RE: AURORA FOOD STORE
 2000 ANAQUOD ROAD
 REGINA, SK
 Commission No. 2445

RE: Fixture Plan R03 Pharmacy Consultation Room

PROPOSED CHANGE NOTICE

2445-27

| | DRAWING REVISE DRAIN FOR SINK | DWG NO. MP-05A |

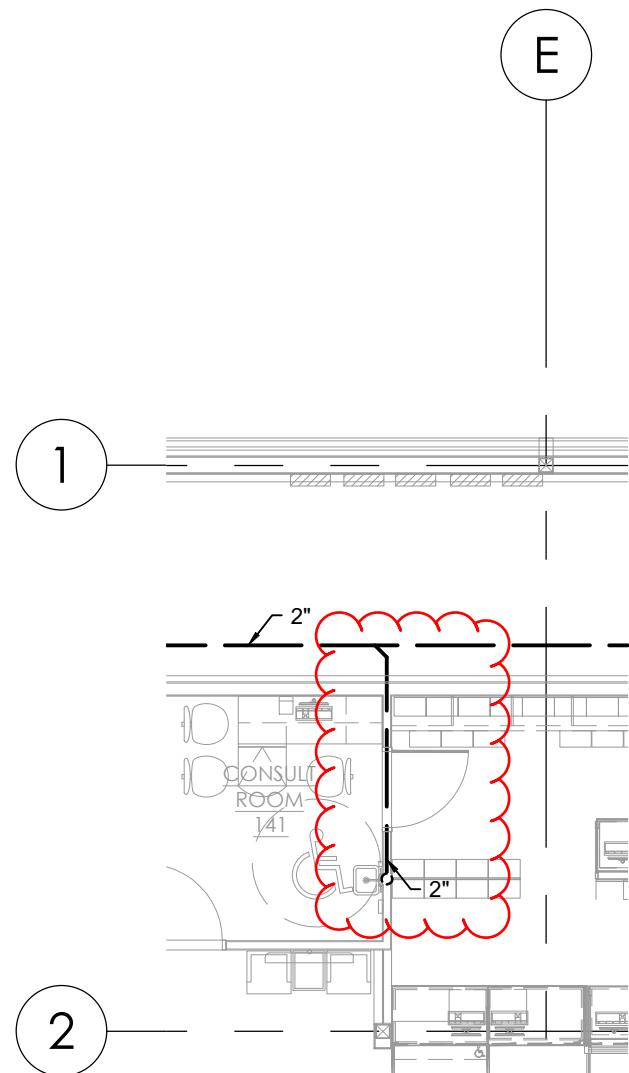
1. Revise the pharmacy sink to a wall-mounted style. Revise the location of the drain, vent and domestic water lines as shown on mechanical revision drawings MP-05A and MP-05B. Final sink selection to comply with Saskatchewan Health Authority standards.

| | R03 | |

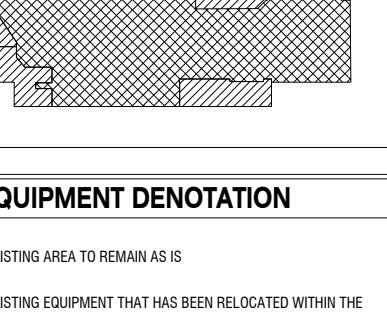
ARMACY
ARGED CONSULT ROOM, INTERIOR
ALL SHIFTED 2' TOWARDS WAITING AREA
VIOUSLY PLANNED SINK WITHIN THE
NSULT ROOM MILLWORK HAS BEEN
MOVED
ALL MOUNTED HAND SINK WILL BE
TALL IN THE SHARED WALL BETWEEN
PENSARY AND CONSULT ROOM
WALL BETWEEN THE CONSULT ROOM
D DISPENSARY WILL BE WIDEN TO 9" TO
COMMODATE PLUMBING AND
RUCTURAL COLUMN
WAITING AREA WALL ADJACENT TOO
K-UP HAS BEEN EXTENDED TO ALIGN
USH WITH THE SALES FLOOR BULKHEAD
~~STORAGE WIDTH REDUCED FORM 5' TO~~
~~3' AS DISPENSARY SHIFTED TO SUOT~~
~~W PLUMBING WALL~~
